1028 MARKET STREET PROJECT

CITY AND COUNTY OF SAN FRANCISCO PLANNING DEPARTMENT:
CASE NO. 2014.0241E

Planning Commission Motion No. 19842

ADOPTING FINDINGS RELATED TO THE CERTIFICATION OF A FINAL ENVIRONMENTAL IMPACT REPORT FOR A PROPOSED PROJECT WHICH INCLUDES DEMOLITION OF THE EXISTING HISTORIC TWO-STORY COMMERCIAL BUILDING AND DEVELOPMENT OF UP TO 186 RESIDENTIAL UNITS, GROUND-FLOOR RETAIL, UNDERGROUND PARKING, OPEN SPACE, AND STREETScape IMPROVEMENTS.

(REVISED) FIGURE 4.B.1: 1028 MARKET STREET FAÇADE LOOKING NORTHWEST

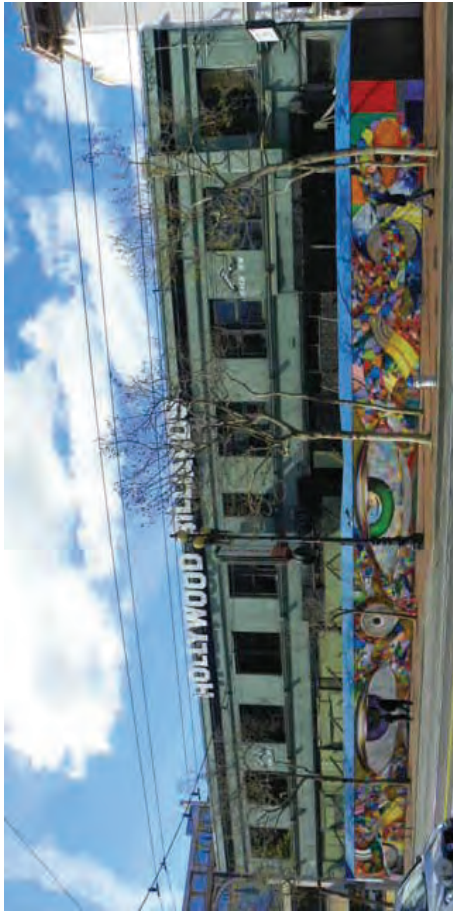
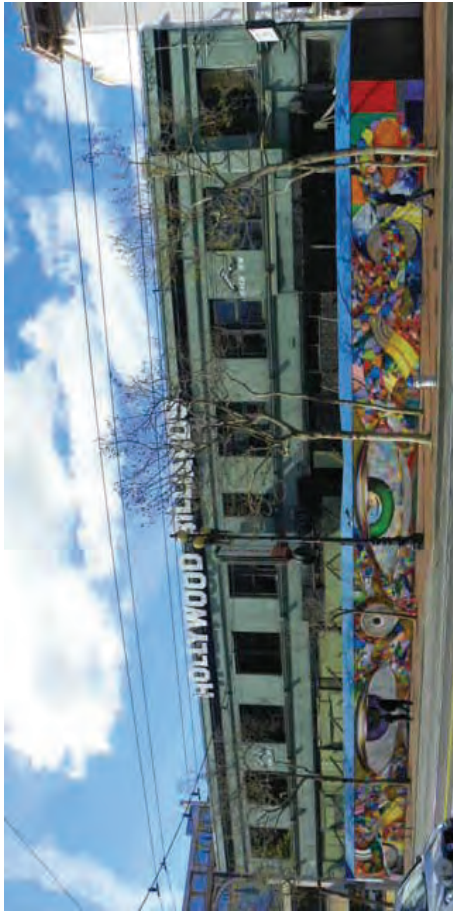
Point No. 2, building description and history, 4B2. Provide better images, old and new, to inform decision-makers about the building and the building in context. The current image, Figure 4B1, makes you hardly realize the building is taken in the spring when all trees are in full green and the building in discussion is hardly noticeable.

More specifically, in response to the request for base images of the existing 1028 Market Street building when street trees are not in full leaf, two revised figures have been provided. The base images for Figure 4.B.1: 1028 Market Street Façade Looking Northwest, on EIR p. 4.B.3, and Figure 4.B.3: View of Golden Gate Theatre Dome from South Side of Market Street, on EIR p. 4.B.35, have been updated with newer higher resolution photographs. In addition, Figure 4.B.1 has been further revised to include an inset image of the existing building prior to its temporary use as a food hall (which started in October 2014). See (Revised) Figure 4.B.1: 1028 Market Street Façade Looking Northwest and (Revised) Figure 4.B.3: View of Golden Gate Theatre Dome from South Side of Market Street.

Figure 4.B.1: 1028 Market Street Façade Looking Northwest, on EIR p. 4.B.3, has been revised to replace the existing photograph with a newer, higher resolution photograph of the 1028 Market Street building, taken when street trees are not in full leaf so that more of the existing building is visible. An inset image of the existing building prior to its temporary use as a food hall (which started in October 2014) has been added as well. The revised figure is shown on the following page.

(REVISED) FIGURE 4.B.3: VIEW OF GOLDEN GATE THEATRE DOME
FROM SOUTH SIDE OF MARKET STREET

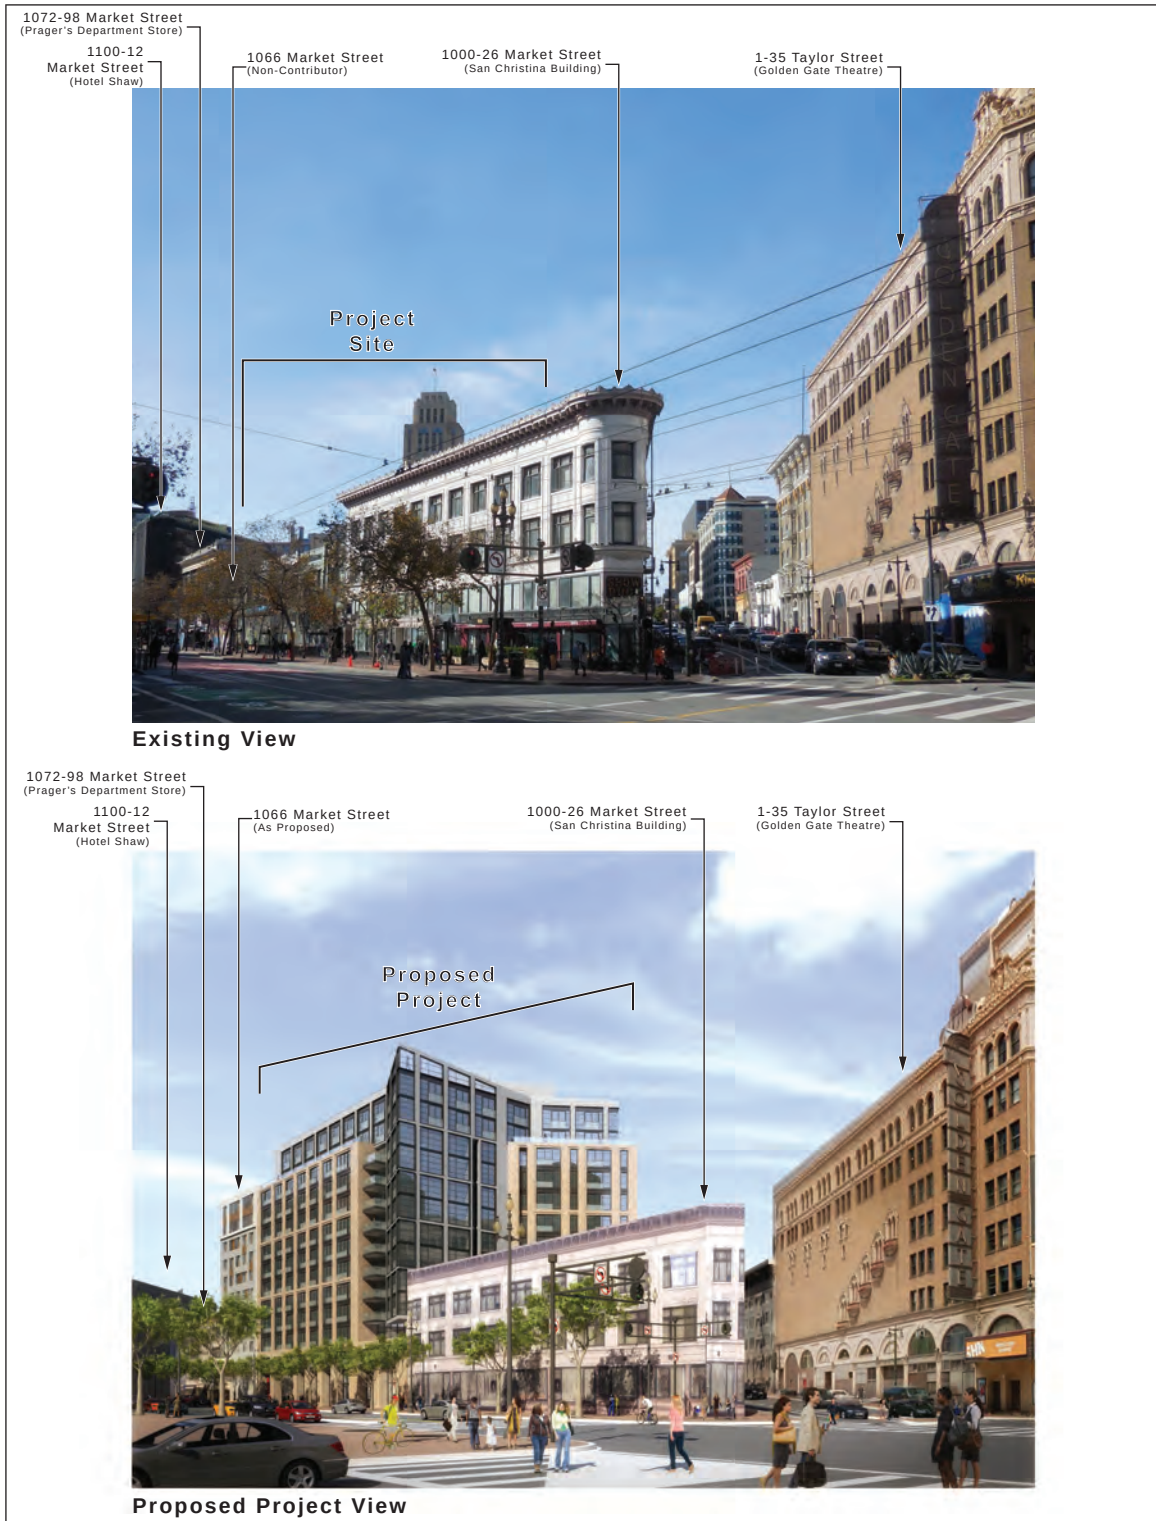
Comments request images that show the existing buildings that contribute to the MSTL District and that are representative of the character-defining features of the MSTL District. The comments also request additional images of the existing building's facade in its MSTL District visual setting so as to better visualize the effects of the proposed project. To facilitate a better understanding of the proposed project in its visual context, three new figures showing pedestrian-level views are presented: RTC Figure 1: View Looking West along Market Street – Existing and Proposed Views, RTC Figure 2: View Looking East along Market Street – Existing and Proposed Views, and RTC Figure 3: View Looking Southeast along Golden Gate Avenue – Existing and Proposed Views. These new graphics show “before and after” images so that the reader can compare existing conditions at the project site to conditions with the proposed building. The “after” images include a rendering of the adjacent development to the west (1066 Market Street).

Figure 4.B.3: View of Golden Gate Theatre Dome from South Side of Market Street, on EIR p. 4.B.35, has been revised to replace the existing photograph with a newer, higher resolution photograph, taken when street trees are not in full leaf so that more of the existing building is visible. The revised figure is shown on the following page.
